USB 3.0 ENGINEERING CHANGE NOTICE

ECN# 006

Title: USB3.0 State Machines ECN

Applied to: USB3.0 (11132008)-final

Figure 9-1. Peripheral State Diagram & Hub State Diagram (SuperSpeed Portion only)

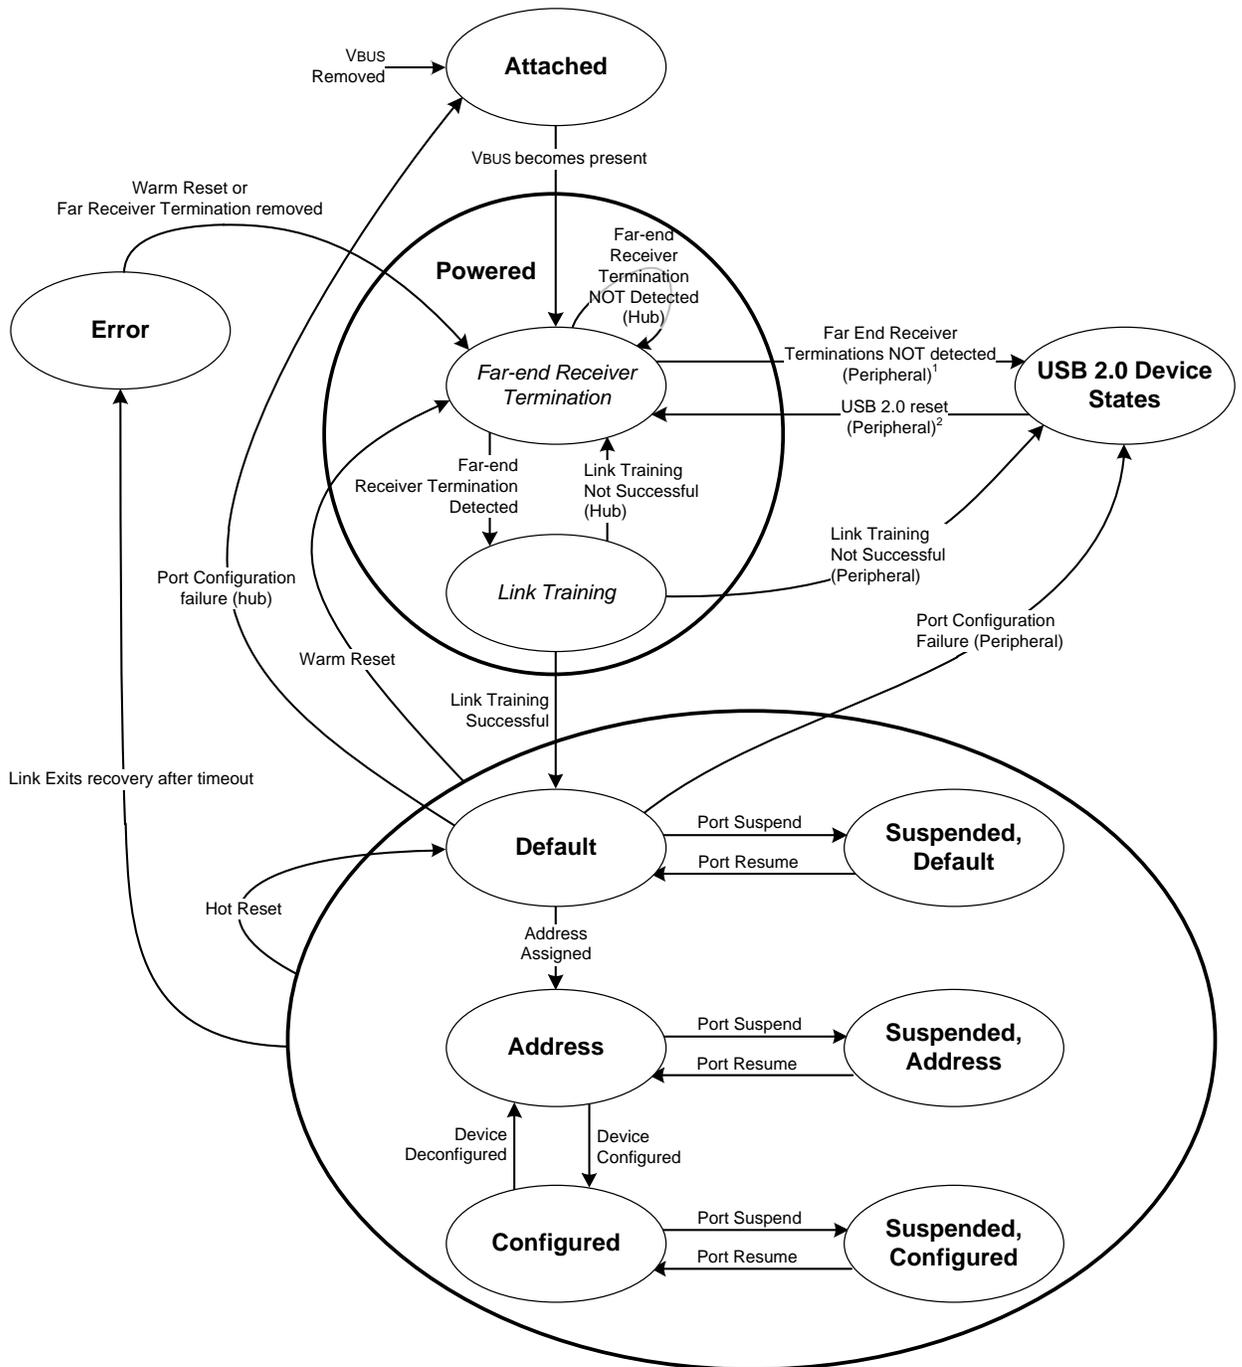
(b). Amendments to Section 9.1.1(Figure 9-1/9-2)

Update section and figure to reflect discrepancies identified by the OTG WG and clean-up references to the state that must be saved during suspend.

Figure 9-1 is a combined state diagram for both peripherals and hubs. Note that a USB 3.0 Hub has two discrete state diagrams, one for the SuperSpeed portion shown in Figure 9-1 and another for the non-SuperSpeed portion which may be found in Figure 9-1 in the USB 2.0 Specification.

(d). Amendments to Section 10.5 (Figure 10- 11)

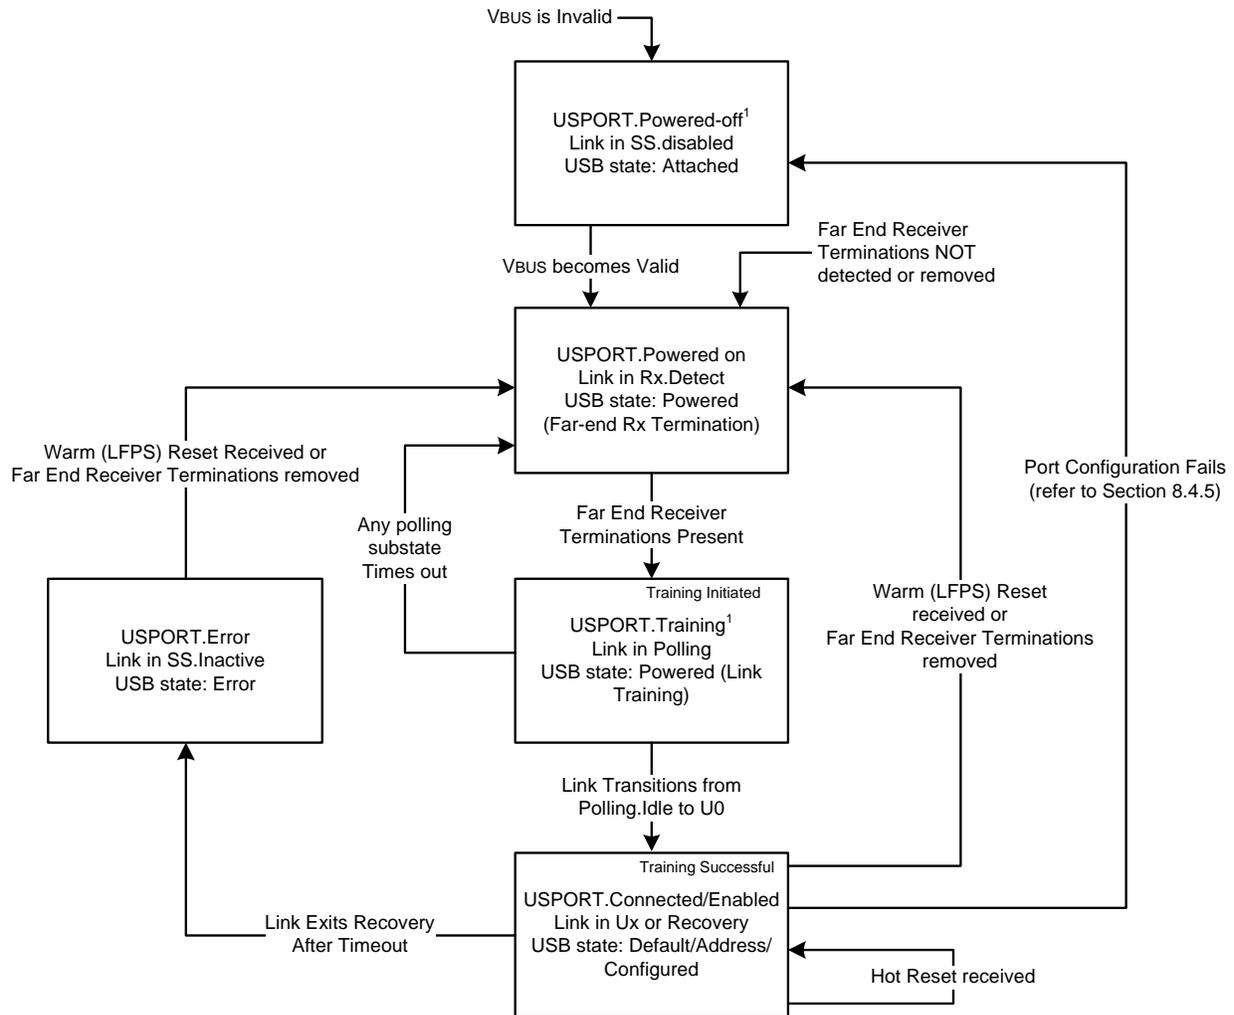
Replace current Figure 10-11 in Section 10.5 with the figure below:

¹ If Port Configuration fails, the port shall transition to the USPORT.Powered-off state with the link in SS.Disabled state and USB Device in the Attached state. Vbus may still present on the upstream port. Vbus must be toggled to transition to the USPORT.Powered on state.

Figure 10-15. Peripheral Upstream Device Port State Machine

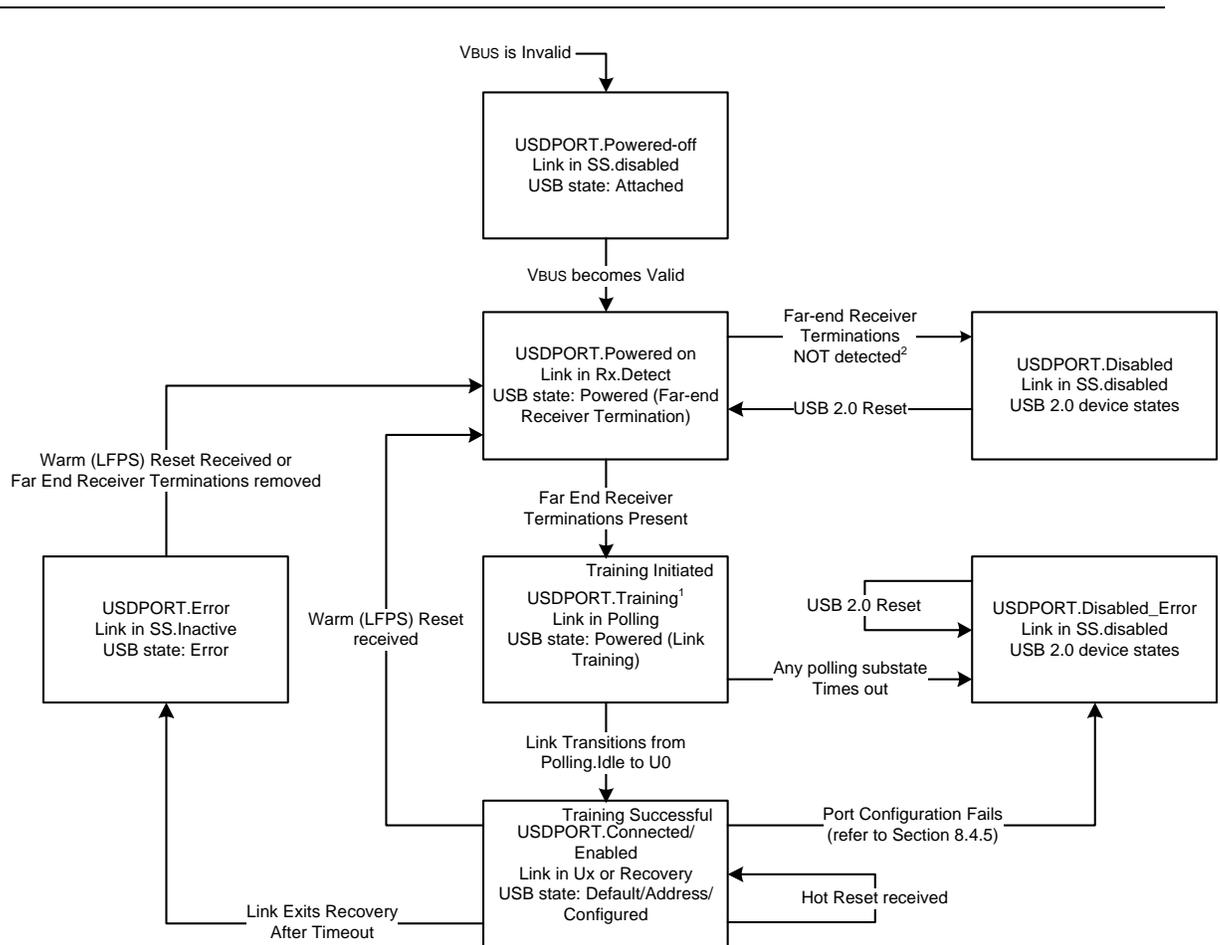
(e). Amendments to Section 10.16.2 (Figure 10-25)

10.16.2 Peripheral Device Upstream Port State Machine

¹ Peripheral Device must disconnect on USB2.0 within tUSB2SwitchDisconnect of entering this state

² If USPORT.Powered on was entered from any state except USPORT.Disabled then this transition shall take place if Far-end Receiver Terminations (RRX-DC) are not detected after 8 successive Rx.Detect.Quiet to Rx.Detect.Active transitions. If USPORT.Powered on was entered from the USPORT.Disabled state, then this transition shall take place the first time that Far-end Receiver Terminations are not detected in the Rx.Detect.Active substate.
